# CITY OF SMYRNA

### MEMORANDUM

**RE: VARIANCE CASE V25-052**  
**1241 Kingsview Drive – Allow encroachment into the City’s 50-foot undisturbed stream buffer**

**VARIANCE CASE V25-053**  
**1241 Kingsview Drive – Allow encroachment into the City’s 75-foot impervious surface setback**

Figure - 2  
Proposed Site Plan

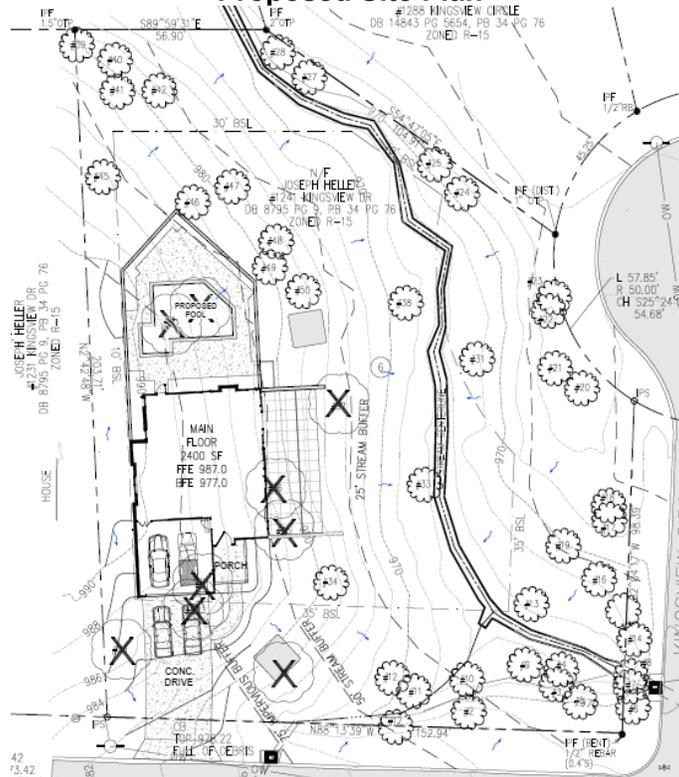
In order to construct the new home, the applicant will disturb the City’s 50-foot undisturbed stream buffer and the City’s 75-foot impervious surface area setback by 3,705 square feet. The applicant will mitigate the disturbance by installing two bmps with a gravel sump system in both

the front and side yard. The Engineering Department has reviewed the application and accompanying mitigation plan and supports the method used for buffer mitigation per the Georgia Stormwater Management Manual requirements.

1. Approval is conditioned upon substantial compliance with the elevation and site plan submitted with the variance application.
2. A Stormwater Inspection and Maintenance Agreement shall be completed and recorded with the Cobb County Superior Court prior to issuance of the building permit.
3. A stormwater as-built certification statement shall be submitted to Community Development for approval prior to issuance of the building permit Certificate of Completion.
4. Any damaged or broken curb caused during construction shall be replaced prior to issuance of the building permit Certificate of Completion.
